Amendment #4

AMENDMENT #4
CMHC RFP for Landscape Maintenance Services for Granville Island
RFX000052
Submission Deadline: 11:00 AM PST, November 19, 2018

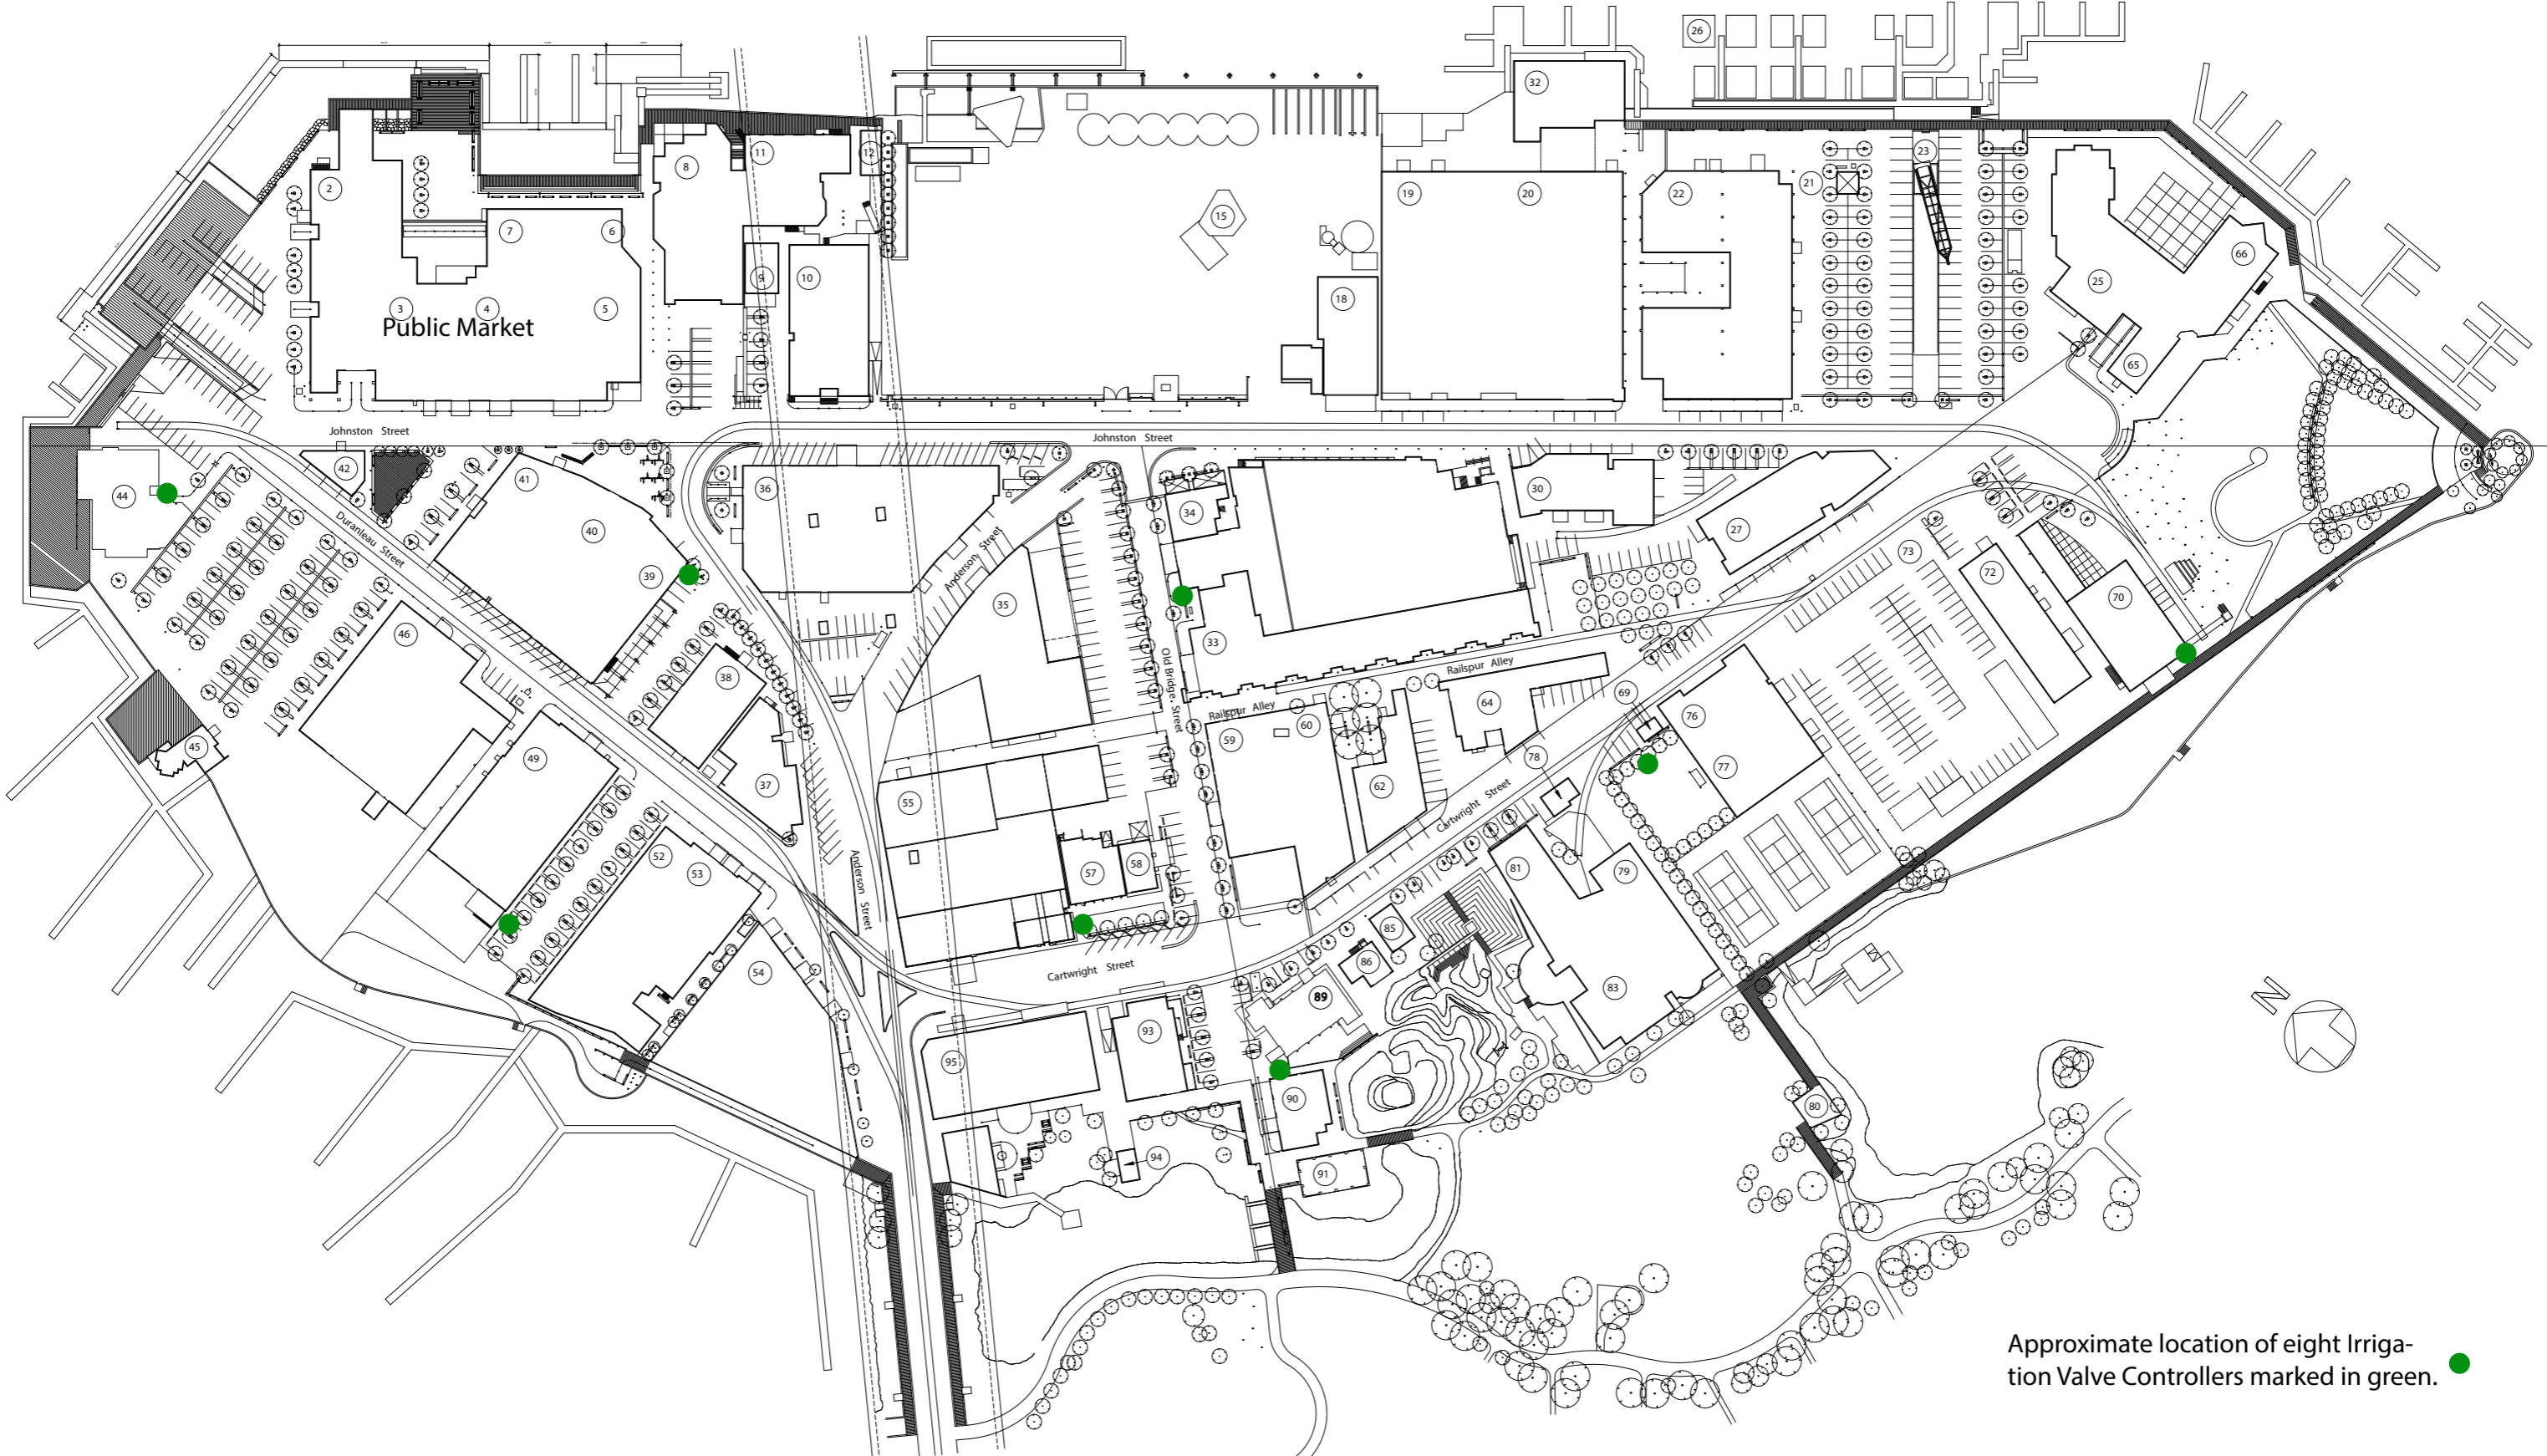
Q26. The map included in the RFQ says, "Landscaping adjacent to the Granville Island Hotel is excluded". Is this all of the landscaping surrounding (attached to) the hotel? If not can you provide clarity on which areas are adjacent.

A26. Area highlighted in Red around the Granville Island Hotel is excluded. This includes all landscaping attached to the building and surrounding the patio area.
